## **PROVISION POINTE SUBDIVISION**

***Revised for the December 1, 2011, meeting***

***Revised for the December 15, 2011, meeting***

## DETAIL SITE PLAN

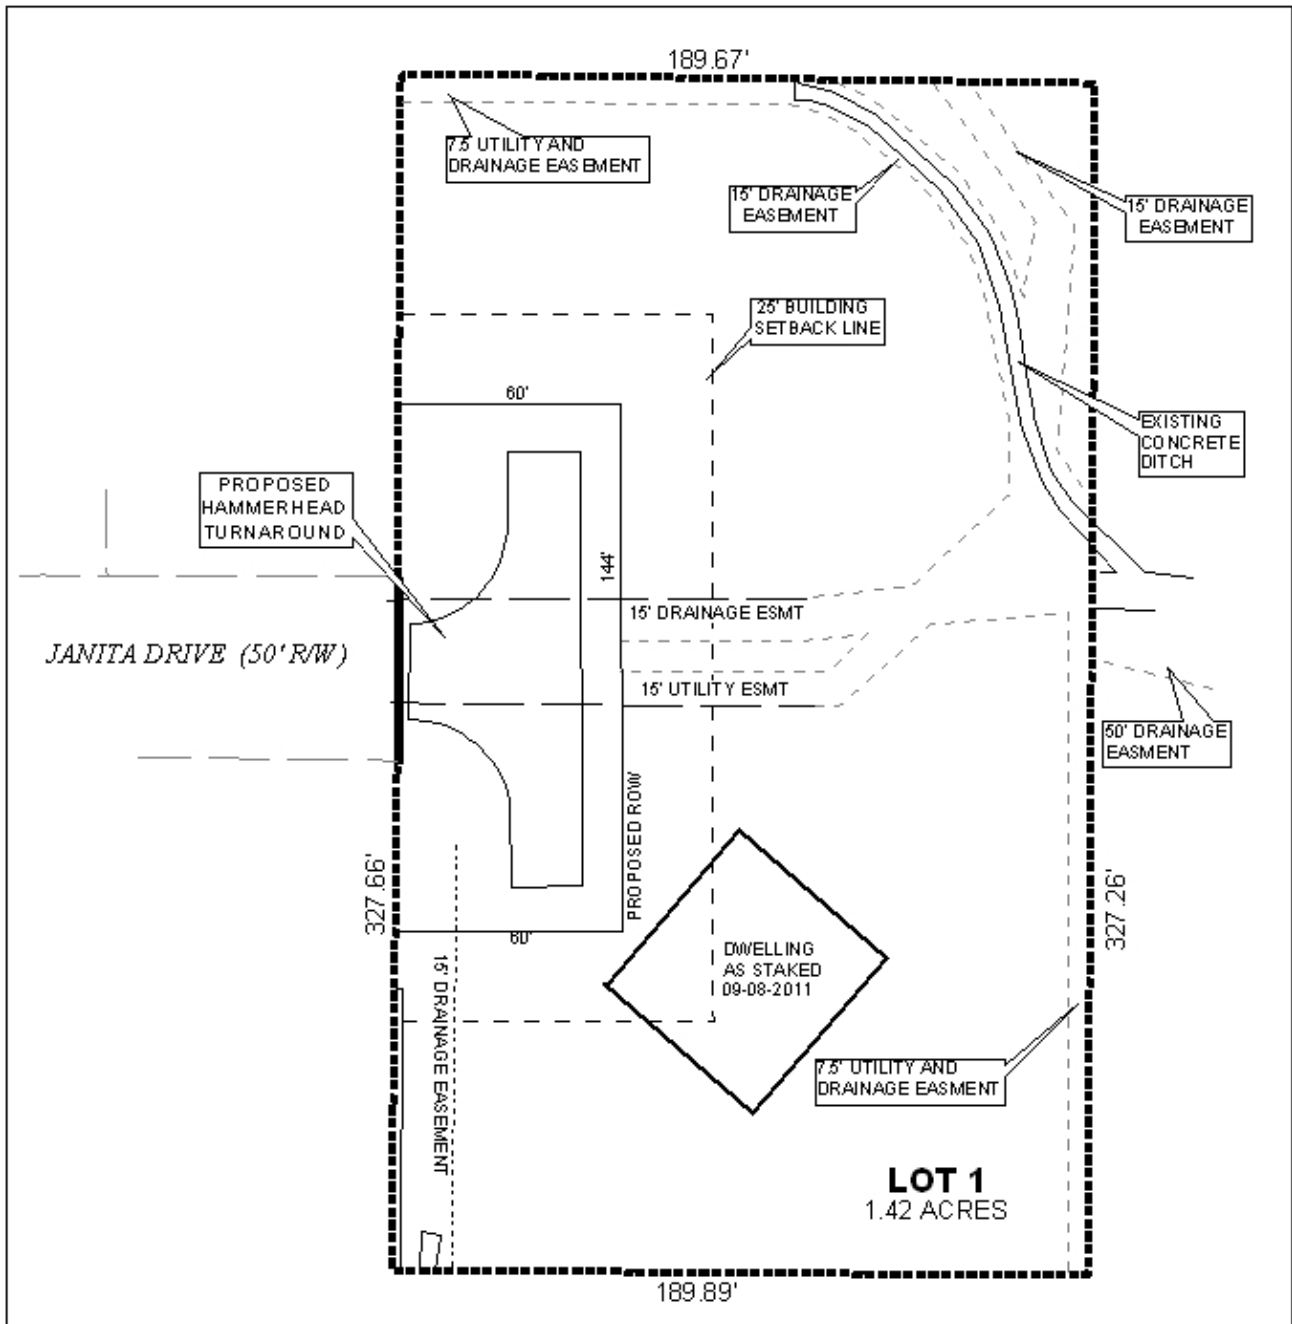
The proposed lot is located at the end of Janita Drive, which is a minor, closed-end street provided with curb and gutter, but not provided with a cul-de-sac or turnaround. Section V.B.6. of the Subdivision Regulations requires a turnaround to be provided at the end of a closed-end street. The applicant has requested a waiver of the requirement of turnaround construction because of cost and because of the setback line that the turnaround would create. It should be noted that the Planning Section has received letters and inquiries from other property owners along Janita Drive expressing concern that there is not a turnaround at this location and concern over the possibility of a turnaround not being provided.

Section V.B.14. of the Subdivision Regulations requires a 120-foot diameter cul-de-sac turnaround for a closed end street. The applicant states that this requirement would cause the proposed lot to be unbuildable. Even as this assertion was made, the Preliminary Plat depicts the required cul-de-sac with plenty of room for a dwelling to be constructed.

The applicant is also requesting a waiver of Section V.D.9. of the Subdivision Regulations regarding the 25-foot minimum building setback line. Again, the applicant states that the 25-foot minimum building line would render the lot unbuildable, and instead requests a 20-foot minimum building line. The Preliminary Plat and available evidence indicates that this assertion is not correct, and that, even with a minimum building line of 25 feet, there is still plenty of space to construct a dwelling.

Without the waivers requested, the lot will meet the minimum requirements of the Subdivision Regulations. It should be noted that, while the lot area size is depicted on the Preliminary Plat, it does not include the dedication required for the cul-de-sac. As such, the lot area size should be modified to subtract the area dedicated for the right-of-way for the required cul-de-sac.

*The application was heldover to allow the applicant to meet with neighbors and to submit a revised plat illustrating a 2009 International Fire Code compliant hammerhead turn-around. The revised plat was submitted on November 7, 2011, and depicts a 120-foot hammerhead turnaround which is compliant with the 2009 International Fire Code. The right-of-way dedication should be labeled as such. The 25-foot building setback is depicted, however, the plat shows a building staked within the building setback area. The building should be removed from the building setback area.*

- 1) *construction and dedication of the 120-foot hammerhead turnaround and associated right-of-way at the terminus of Janita Drive as depicted;*
- 2) *retention of the 25-foot minimum building setback line around the hammerhead turnaround as depicted;*

- 3) *retention of the lot area size, in square feet, exclusive of any area dedicated for the required turnaround;*
- 4) *removal of the proposed structure from within the minimum building setback;*
